<b>marantz®</b> <b>SERVICE BULLETIN</b>		Date: 17-Jul.-2002	Model: PM4200
		Page: 1/2	REF.NBR: MZ02-009revision
Subject:			Problem with incorrect operation of MUTE.
			Int.ref:
Circulation:	Application:		
<input checked="" type="checkbox"/> for information customer complaint in case of service mandatory .....	See below

Processing figure (Part side view)

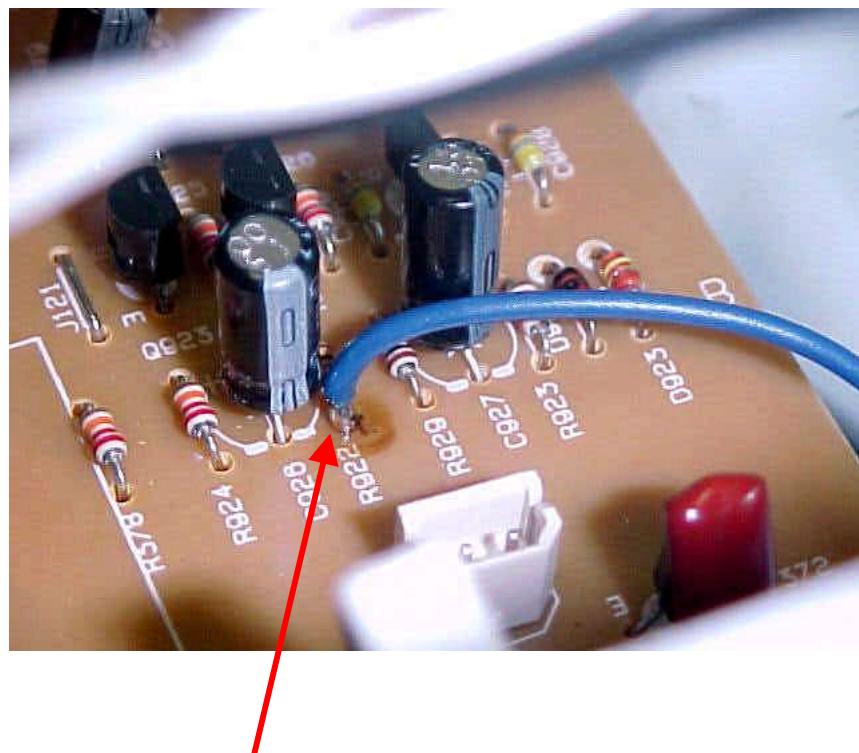
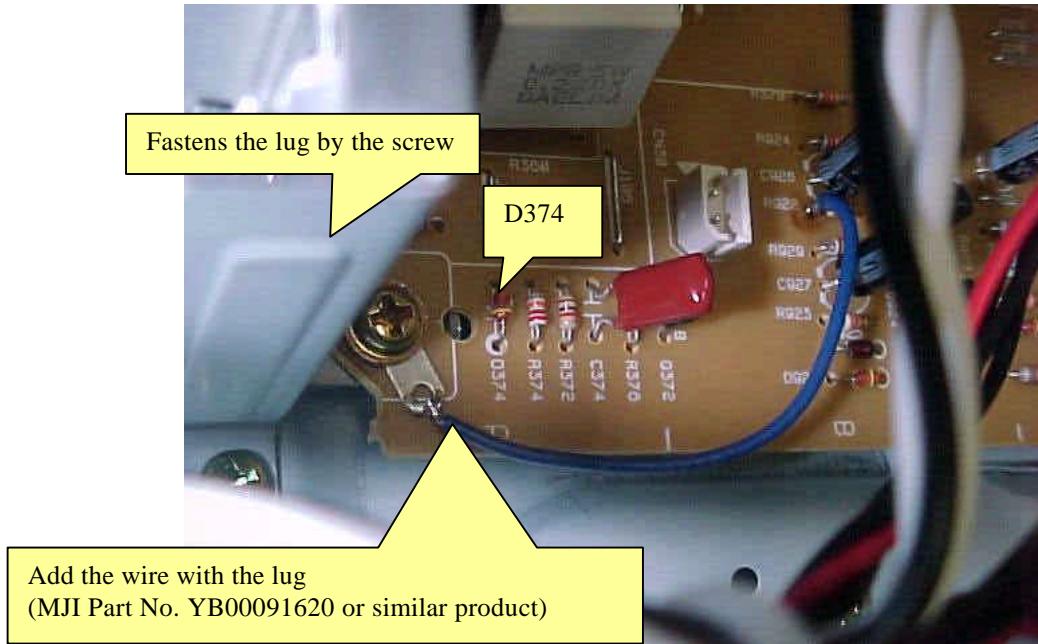
The MUTE LED sometimes blinks and the sounds from output intermit.

Contact error between the bracket (Pos. No. 30) and the ground of INPUT/AMPLIFIER PCB (Pos. No. 29).

Contact to the ground certainly by the wire with the lug.

The wire with the lug: (MJI Part No. YB00091620 or similar product)

**Solder the wire to the ground side lead of the R922 or R929**
